MEMORANDUM

Construction Project
FSA 0503-081
Proj. Code: 19751

DATE: November 26, 2014
TO: All Holders of Plans for Project FSA 0503-081
SUBJECT: Revision No. 2 (to be acknowledged in all Bid Proposals)

**COLORADO
 DEPARTMENT OF TRANSPORTATION
 SPECIAL PROVISIONS
 US 50 - McCulloch Blvd to Wills Blvd**

Sheet Number 237b

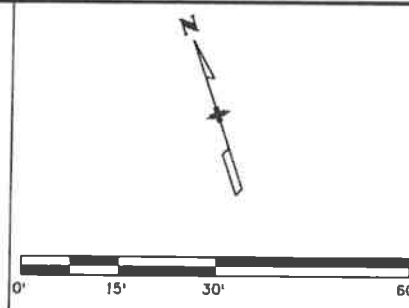
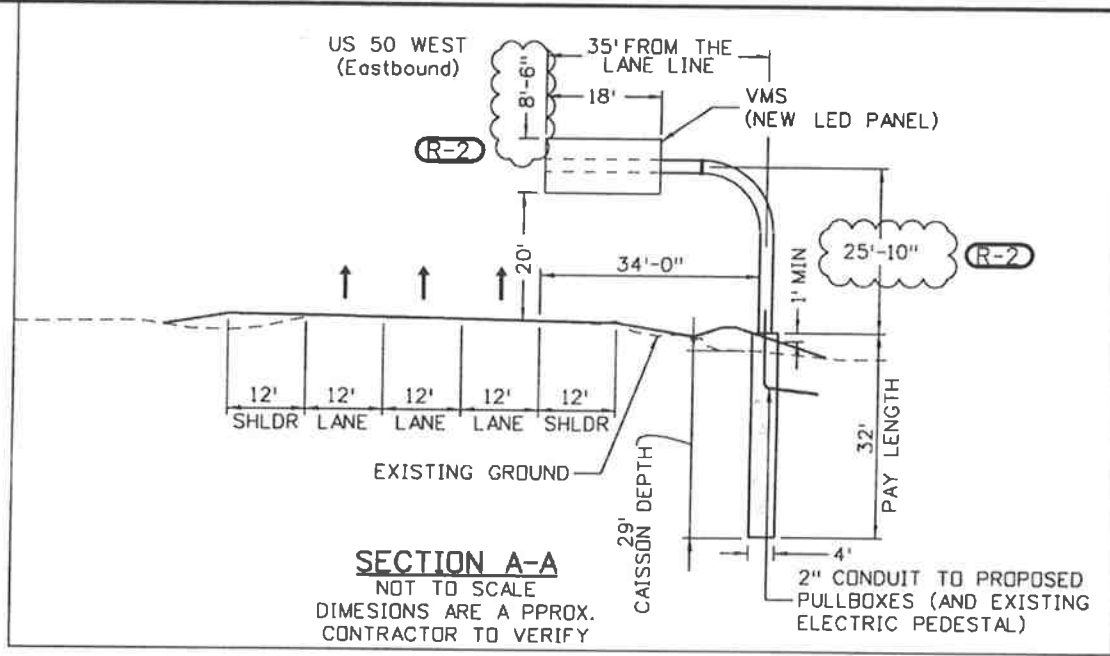
Sheet 1b – Revised Index of Sheets
Sheet 14b – Deleted Item 606-01460 – Median Terminal
 Added Item 606-21010 – End Anchorage (Tensioned Cable Barrier)
Sheet 16b – Added Item 630-80355 – Portable Message Sign Panel
 Deleted Item 630-80359 – Portable Message Sign Panel
 Added Item 630-85041 – Mobile Attenuator
Sheet 21b – Deleted Item 606-01460 – Median Terminal
 Added Item 606-21010 – End Anchorage (Tensioned Cable Barrier)
Sheet 237b – Added Item 630-85041 – Mobile Attenuator
 Revised Item Code for Portable Message Sign Panel
Sheet 304b – Revised height of VMS Panel & Montube

Date:	Comments	Init.
11/20/14	Qty Change	GV
11/26/14	Qty & Code Change	GV

Project No./Code
FSA 0503-081
19751
Sheet Number 304b

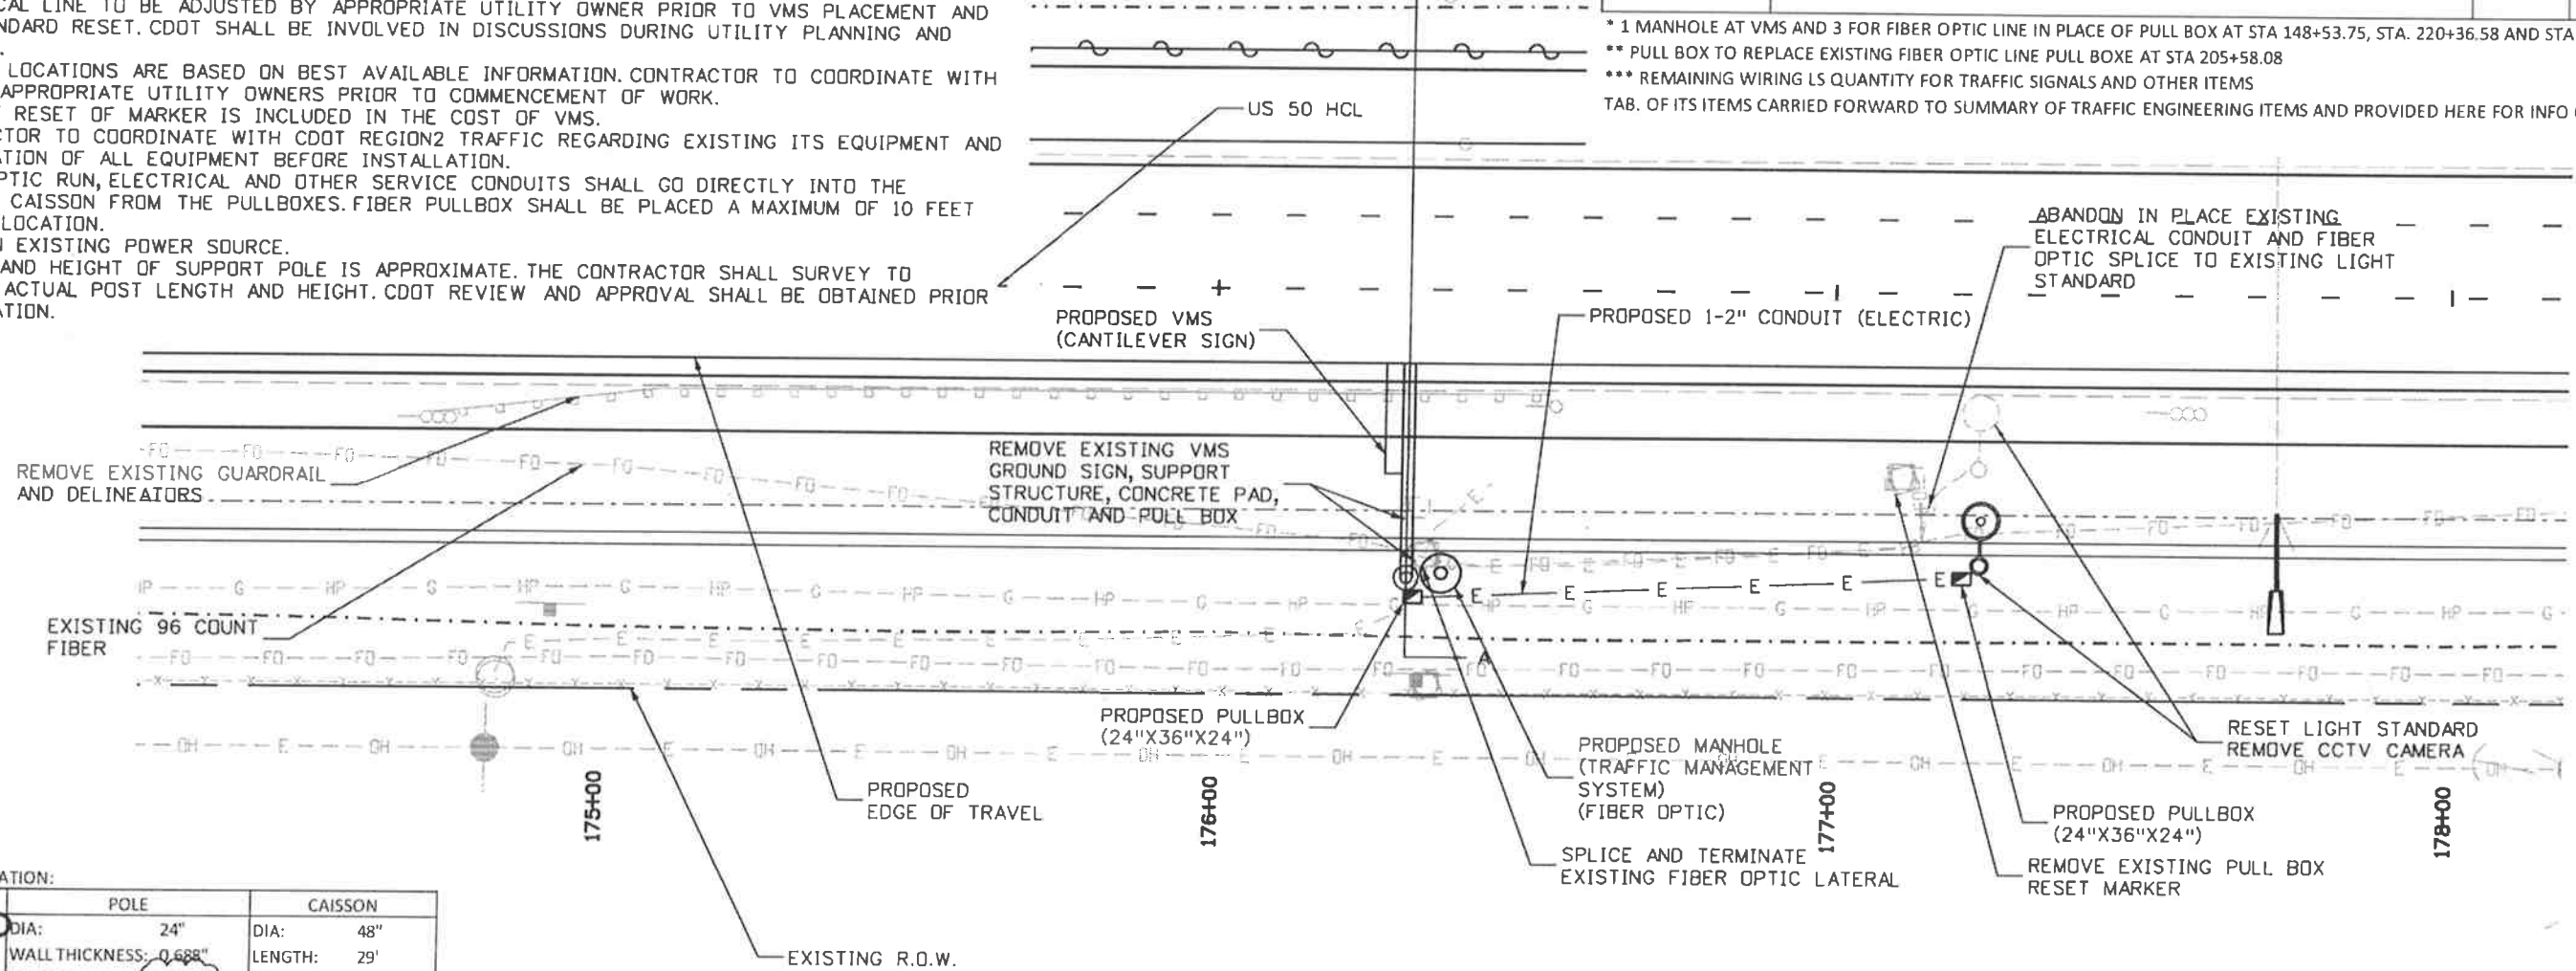
Sheet Revisions			
Date:	Comments	Init.	
11/26/14	Item Del./Add; Dim. Chg	GV
